INDIANA & MICHIGAN ELECTRIC CO. DONALD C. COOK NUCLEAR PLANT

2NSW-117 Upper Containment Ventilation Unit 3 Return Line

DATE: 8/77 DWG. NO. 2NSW-117

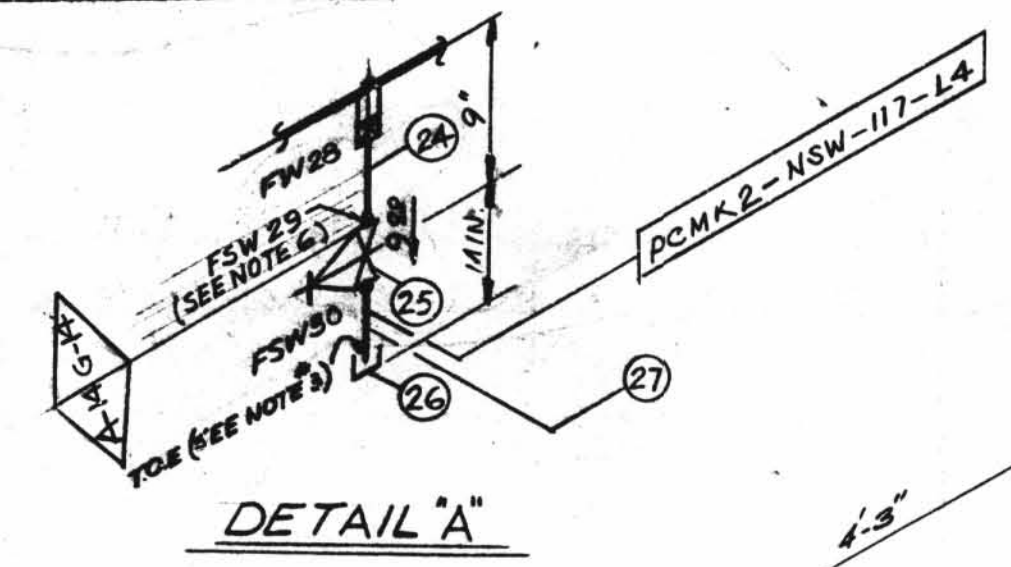
NO.	DATE	DR.	CHK.	DESCRIPTION	REMARKS
1	10/76	DR.	BR.	REVISED BY A.E.P. DESIGN: PER RFC-DC-12-671: ADDED: 3" BW CONTROL VALVE WCR-930, (2) VENTS-VALVE NR. Y-100T23, 1/2" DRAIN-VALVE NR. Y-050T23. MOVED SPEC BREAK FROM WCR-931 TO WCR-930	ACTION REQ'D.
2	12/76	DR.	BR.	REVISED PIPING AT EL. 641'-0" & EL. 618'-8"	ACTION REQ'D.
3	12/76	DR.	BR.	ADDED: WPX-931, REVISED ITEM 15, VENT PIPING. ADDED ITEM 17, 18, 19, NTI-931 WAS 927.	
4	1/77	DR.	BR.	PER RDM-NC-0162 ITEM 15 WAS Y-100T25, ADDED ITEMS 20, 21, 22	
5	1/77	DR.	BR.	PER RFC-DC-12-2549 ADDED PIPE SPEC. G-14, DIM'S, 2-NSW-117-6-7 PC-MK-L4 WELD BOX, NOTES 5, 6 & 7, FIELD WELDS 23 TO 28, FSW 29 X 30. ITEM N.B.S. 23 TO 27 TO B/M. REVISED ITEM NO. 1 & 6 IN B/M. DELETED ITEM NO. 14 FROM B/M.	FIELD ACTION REQ'D.
6	1/77	DR.	BR.	PER REC-DC-12-2549 REVISED PIPING TO CONFORM FIELD DIM'S ROTATED ACTUATOR OF VALVE WCR-930 TO BE TOWARD NORTH	FIELD ACTION REQ'D.

7	1/77	DR.	BR.	PER RFC-DC-12-2549 REVISED DIM'S: DIM'S B/M * DUE TO DRAFTING ERROR DELETED DIM. 2.2 1/4"	NO FIELD ACTION REQ'D.
8	7/77	DR.	BR.	TO REFLECT AS-FOUND CONDITIONS FOR REC-DC-12-3010 PER FWR #759 REV. 1: ADDED: DIM'S: REVISED: DIM'S. ADDED: SUPPORT MARK NOS. & SUPERSEDES HGR. ISO #2-6NSW-117	NO FIELD ACTION REQ'D.
